MODEL
2014MY
Soul (PS)

NUMBER
152 (Rev 1, 10/28/2019)

TECHNICAL SERVICE BULLETIN

SUBJECT: MULTI-FUNCTION SWITCH REPLACEMENT
FOR HEADLAMP FLICKERING

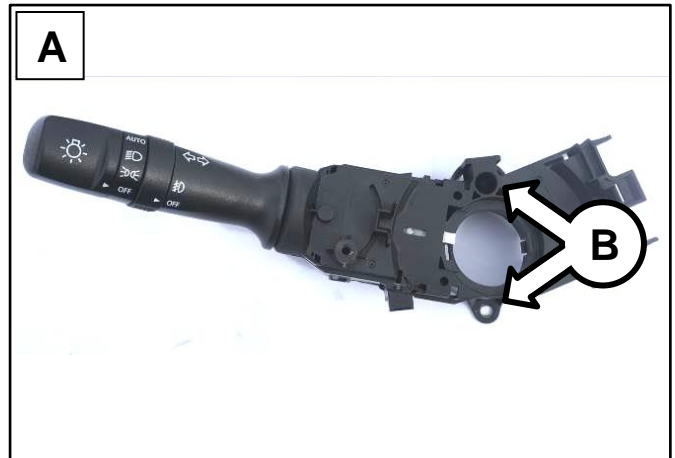
1. Replace the multi-function switch (A) by referring to the “Body Electrical Switch → Multifunction Switch → Repair procedures” chapter in the applicable Shop Manual on KGIS.

*** IMPORTANT**

Be sure to replace the two (2) multi-function switch retaining screws (part no.: 12290 05121) (B) when installing the new switch (A).
